**Metropolitan Branch Trail
ANC 4B Public Works and Infrastructure
Committee**

**Response to questions submitted by ANC 4B Public Works and Infrastructure
committee
September 2017**

Table VII.2 – LOS and Delay for Blair Rd at Aspen St – NB Approach Option 2 (Shared Left/Thru/Right Lane)

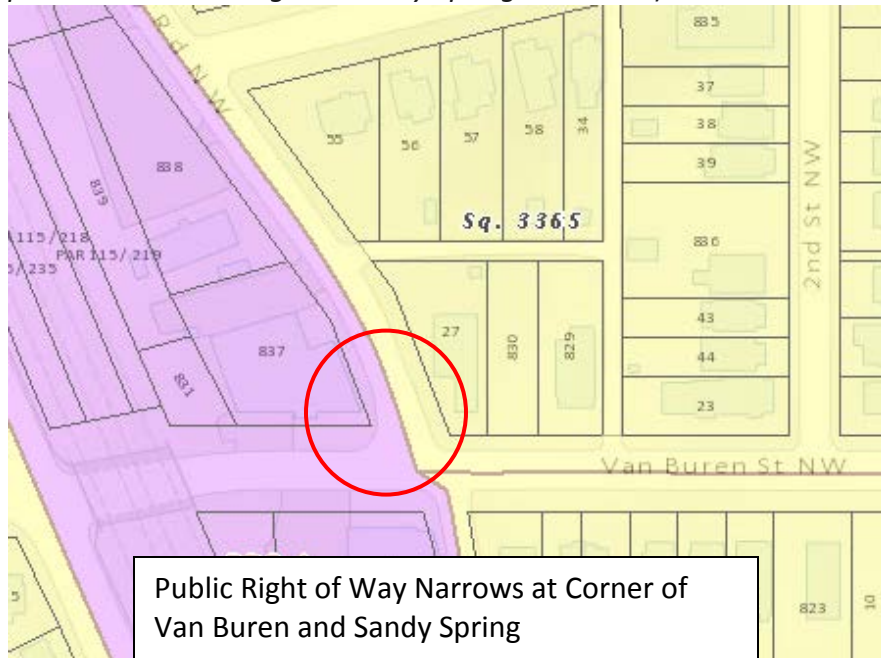
- 2. What is the estimated volume of traffic through the Aspen Street/Blair Road intersection? -- both during rush hour and outside of rush hour? – (once the following facilities are built and in operation: DCI school, the large apartment building at the corner of Aspen and Sixteenth, the recreational facilities in and around Walter Reed's former power plant, the art facilities along Cameron Drive, the three large apartment and condo buildings (V/U) with first floor retail in the building at the corner of Aspen and Georgia, events held on the Great Lawn.)**

The estimated Annual Daily Traffic of Blair Rd at Sheridan St NE is 15,000 vehicles. The impacts of the proposed trail on rush hour traffic were analyzed using a traffic model. The results of the model indicate that the proposed trail and one northbound lane approach of Blair Rd at Aspen St meet an acceptable level of service. While there will be minimal delay for motor vehicles, there will be benefits to pedestrians and bicyclists from the addition of the trail.

The traffic analysis utilized projected future traffic volumes in 2040, which include trips due to adjacent new development (such as Walter Reed) and other increases in vehicle volumes due to overall regional growth. We expect the majority of trips traveling to the new development at Walter Reed to access the site via Georgia Ave. Additionally, trips to the site coming from the east or via Blair Rd are expected to utilize Butternut St to travel east-west. Butternut is a collector street that goes directly into the new development at Walter Reed. It is a wider street designed to carry a higher volume of traffic. Aspen is a local street and does not provide direct access into the site. The traffic model estimates that a small amount (<5%) of traffic will divert to Missouri/5th St NW and Kansas/Eastern Ave NE. However, the current design of the trail will not preclude the addition of a left turn lane at Aspen St if necessary to mitigate future increases in vehicular delay
